Development Review Division

SUBJECT: SP21-063; Douglas 234 F6 L1 - Gas and Convenience Store
Review Comments 01

CONVENIENCE STORE SITE PLAN

LOT 1 OF DOUGLAS 234 FILING NO. 6

PROJECT NO.:	TSD003.01
	DESIGNED BY: LCG
DRAWN BY: JLG	
DATE: 05/27/21	
P0.0

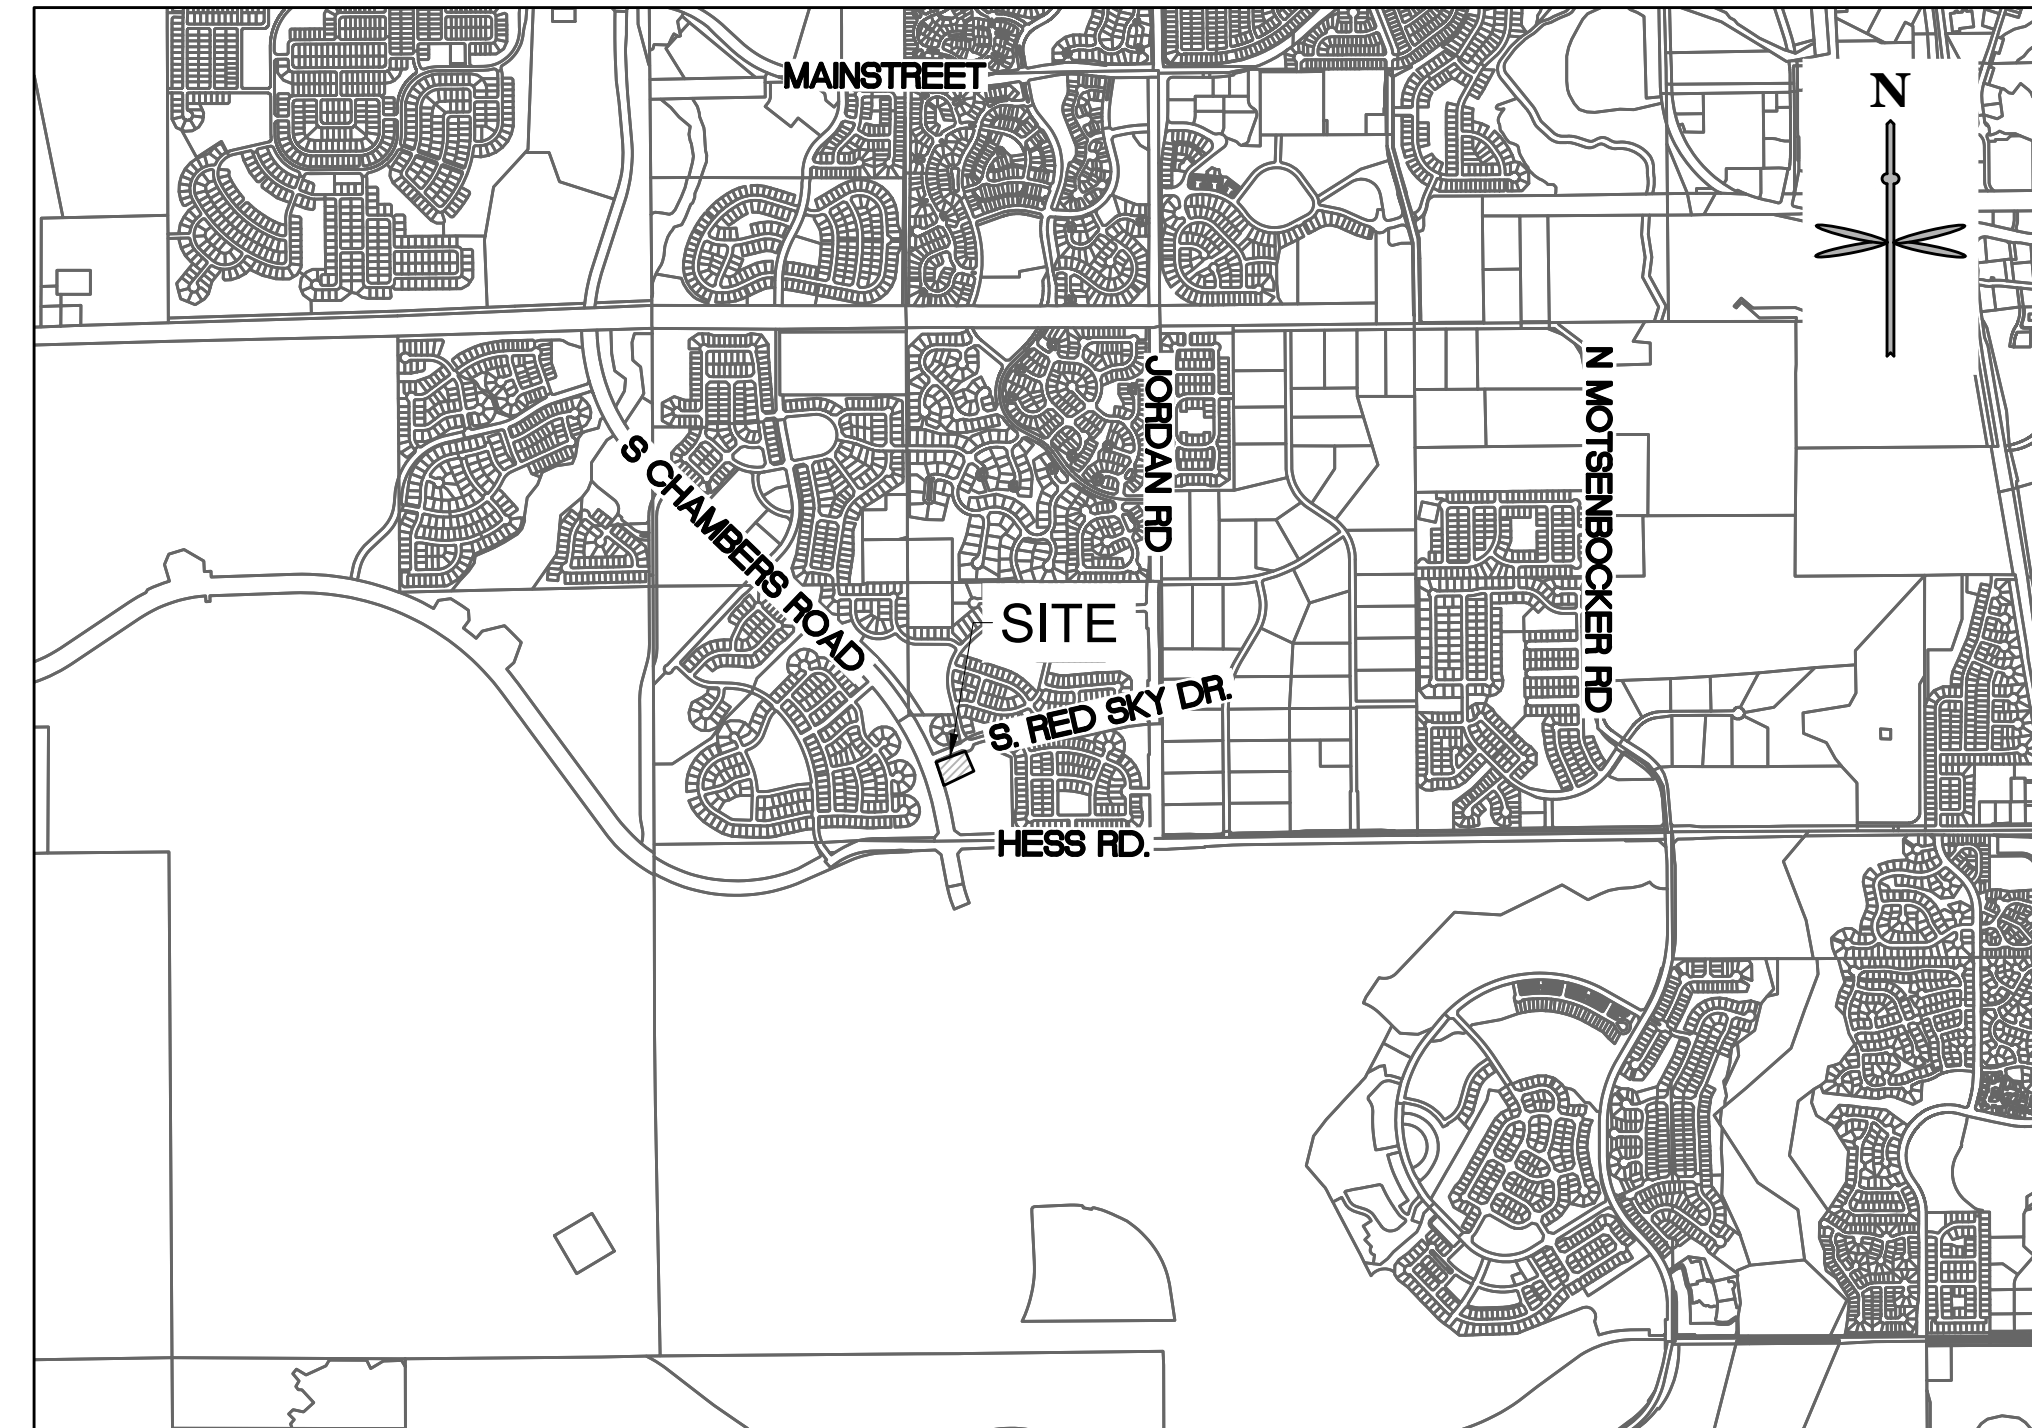
The Legal Description needs to be the main title-switch 1st and 2nd lines

The project has three front yards, N.E, and W.

Based on the code and PD, the N, E, and W all have required 25' setback.

Internal Side (south property line requires 10'

Revise to show accurate required vs. actual

what is labeled side here is actually front, revise

what is labeled rear here is actually side-please revise

No.	REVISION	DATE
	BY	
SITE PLAN LOT 1 CONVENIENCE STORE CHAMBERS AND HESS, PARKER, CO GRADING PLAN		
PROJECT NO:	TSD003.01	
DESIGNED BY:	LCG	
DRAWN BY:	JLG	
DATE:	03/19/21	
P2.0

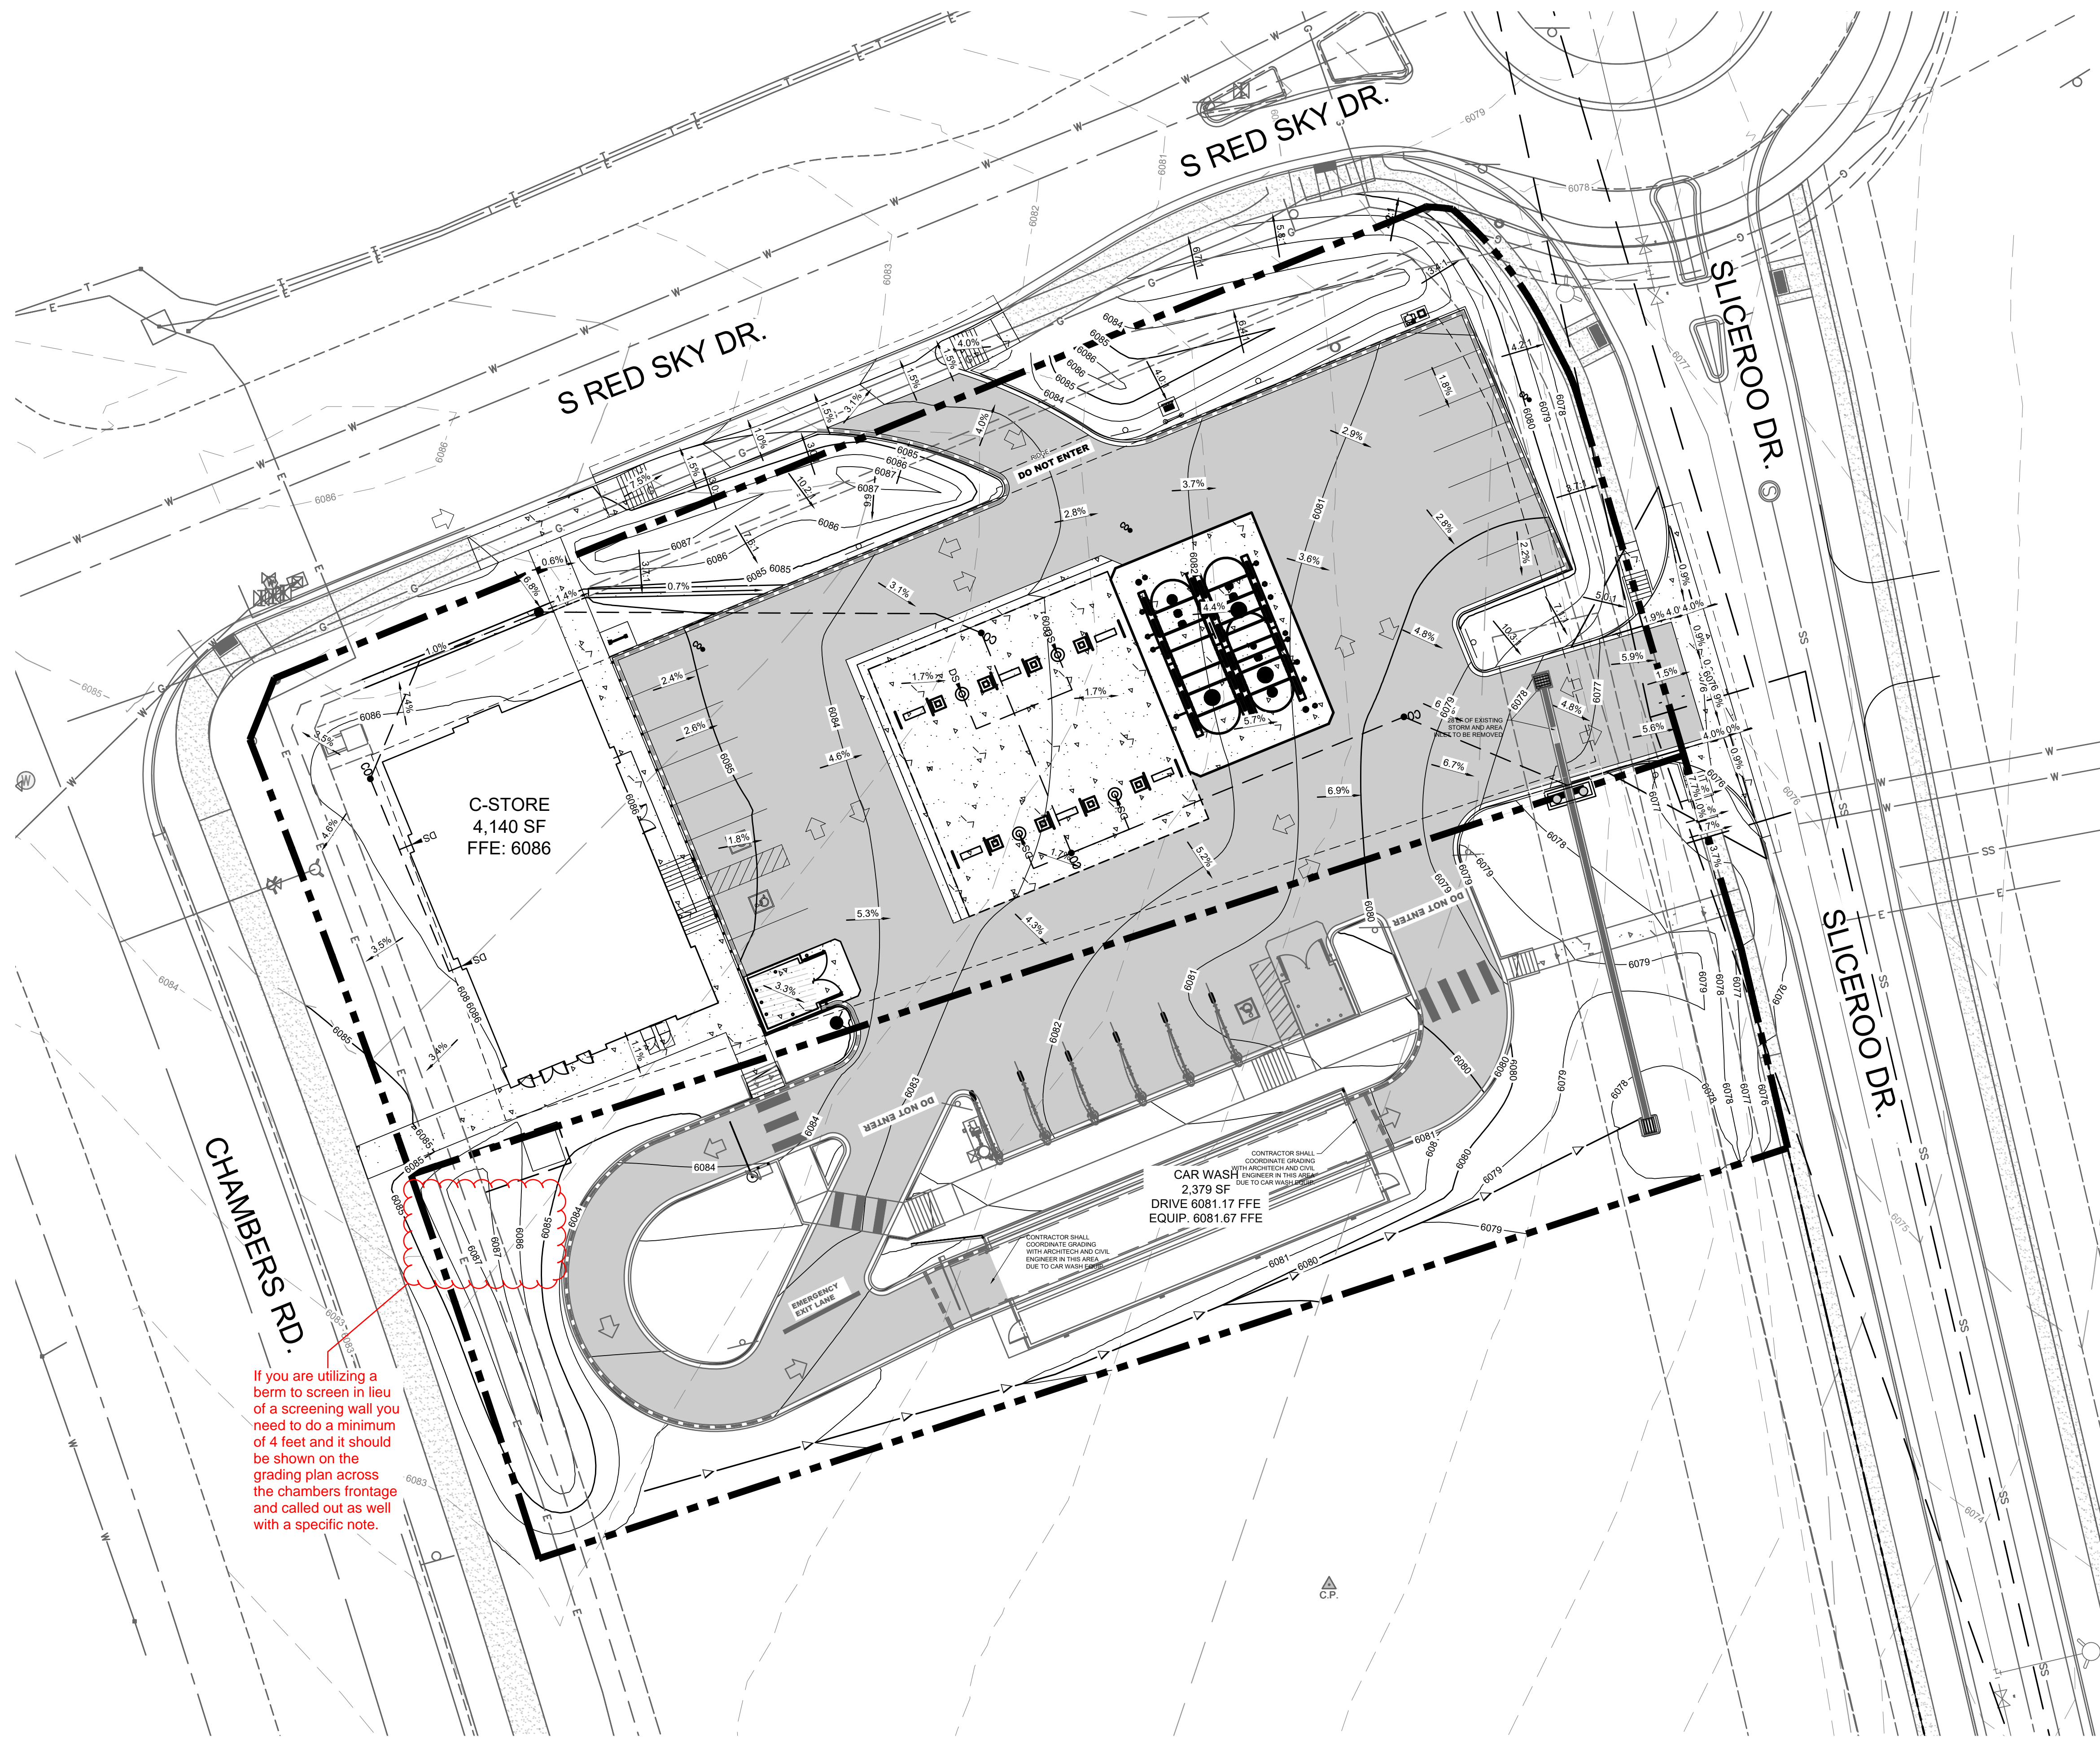
If you are utilizing a berm to screen in lieu of a screening wall you need to do a minimum of 4 feet and it should be shown on the grading plan across the chambers frontage and called out as well with a specific note.

1 LANDSCAPE PLAN

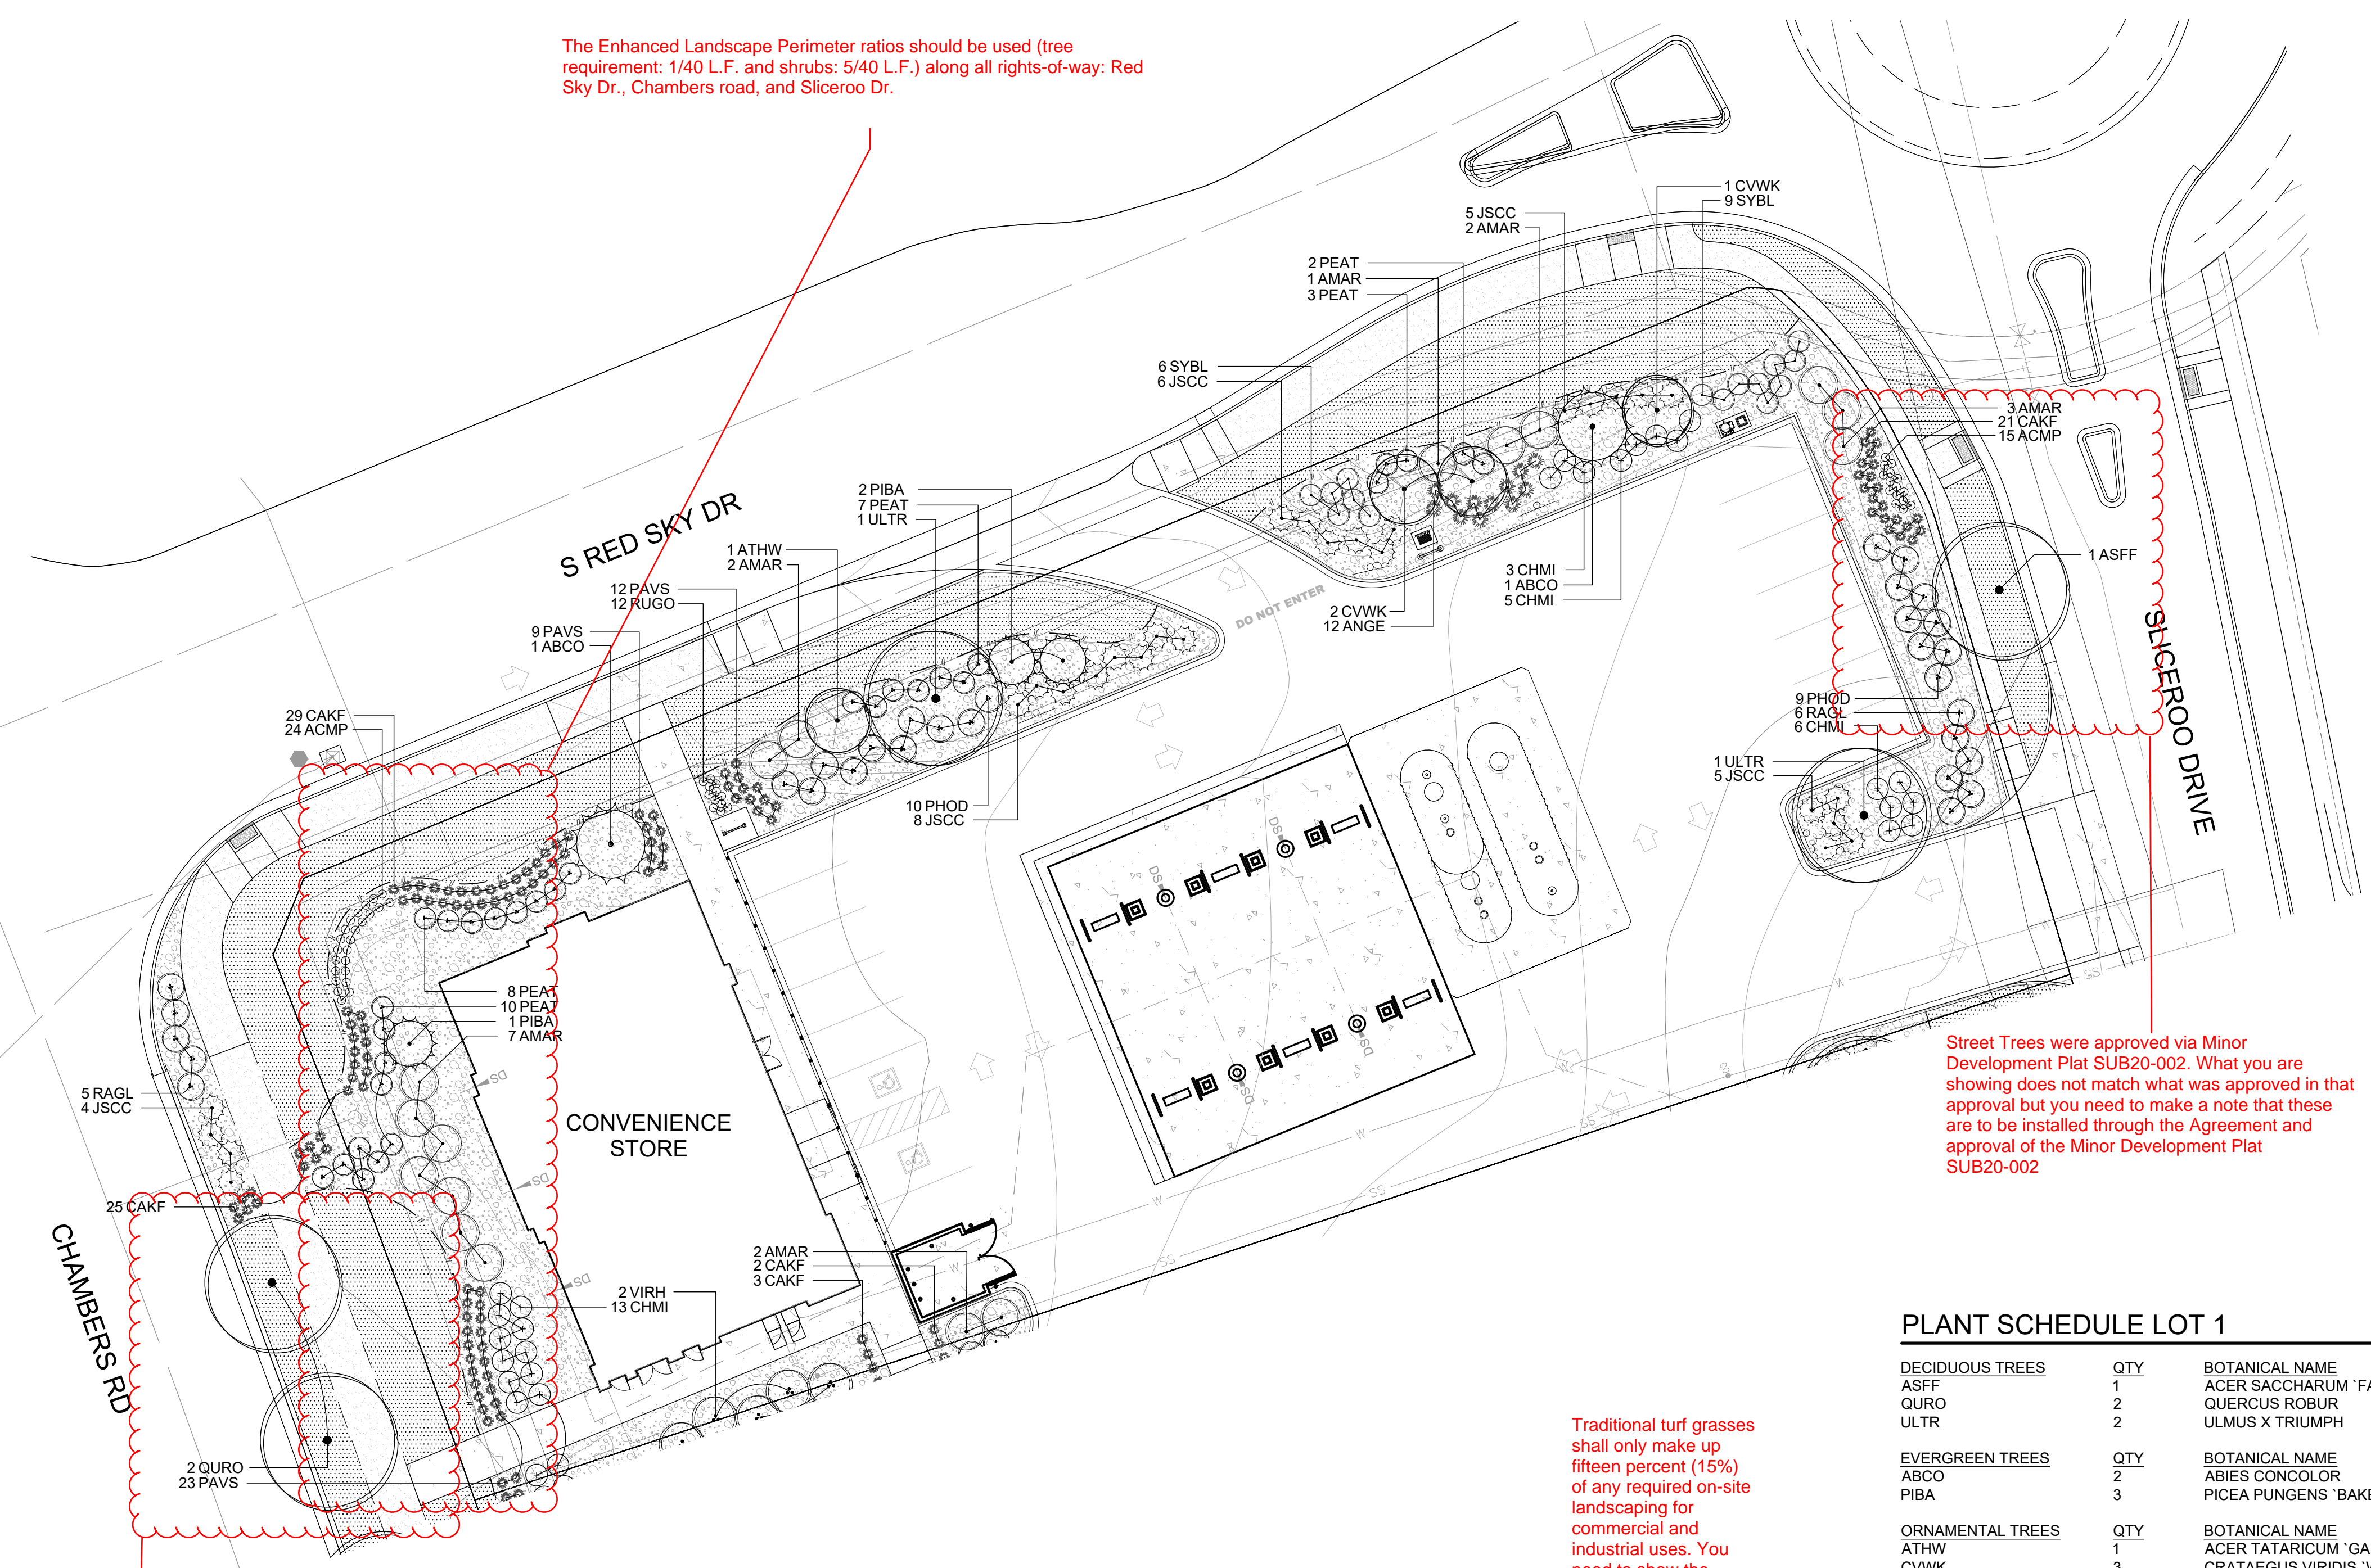
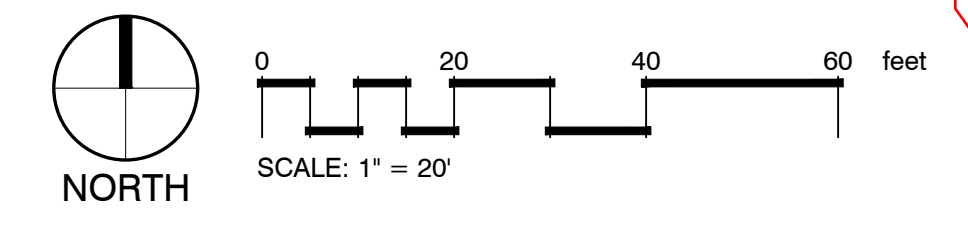
The Enhanced Landscape Perimeter ratios should be used (tree requirement: 1/40 L.F. and shrubs: 5/40 L.F.) along all rights-of-way: Red Sky Dr., Chambers road, and Sliceroo Dr.

Street Trees were approved via Minor Development Plat SUB20-002. What you are showing does not match what was approved in that approval but you need to make a note that these are to be installed through the Agreement and approval of the Minor Development Plat SUB20-002

Traditional turf grasses shall only make up fifteen percent (15%) of any required on-site landscaping for commercial and industrial uses. You need to show the Percentage and compliance.

Include Maturation Heights

Street Trees were approved via Minor Development Plat SUB20-002. What you are showing does not match what was approved in that approval but you need to make a note that these are to be installed through the Agreement and approval of the Minor Development Plat SUB20-002
